INITIAL FIRE SAFETY INSPECTION REPORT

Snowtex Outer Wear Ltd (Extension)

RSC ID: 25770

Table-1: For Building# 10

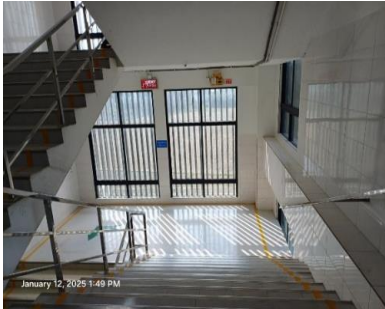
SI No.	Category	Findings	Required Action	Remediation Time Frame
F-1	Means of Egress	The exit stairs are not separated from work areas and other spaces on each floor by fire rated construction due to non functionality of fire door coordinators and the door has not been latched properly. Moreover, The datasheets & certificates of installed fire-rated doors was not available during inspection to verify the credibility of the fire door. Location: Building-10	Provide minimum 2-hr rated fire wall and 1.5-hr fire rated doors for buildings that are 4 or more stories. Seal all unprotected openings to separate the exit stairs from work areas and other building spaces on all floor levels. Ensure that the fire doors are self-closing and positive latching and that they are provided with fire exit (panic) hardware where serving production floors. If fire doors are required to be held open for functional reasons, provide automatic closing devices tied to the fire alarm system. Moreover, The factory shall keep credible datasheets and certificates of installed fire rated doors and their accessories at site to verify during the next inspection.	Within 3 Months

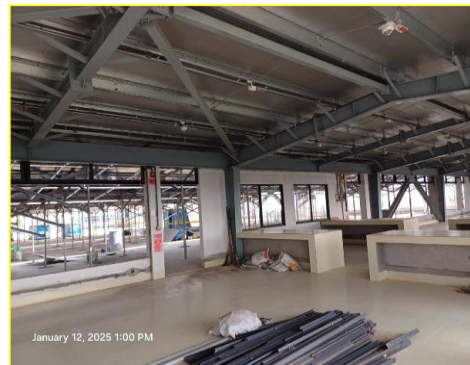
F-2	Means of Egress	Intermediate hand rails has not been provided at stair-4. Location: Building-10	Intermediate handrails shall be provided when the stair width exceeds 2.2 m (87 in.).	Within 3 Months
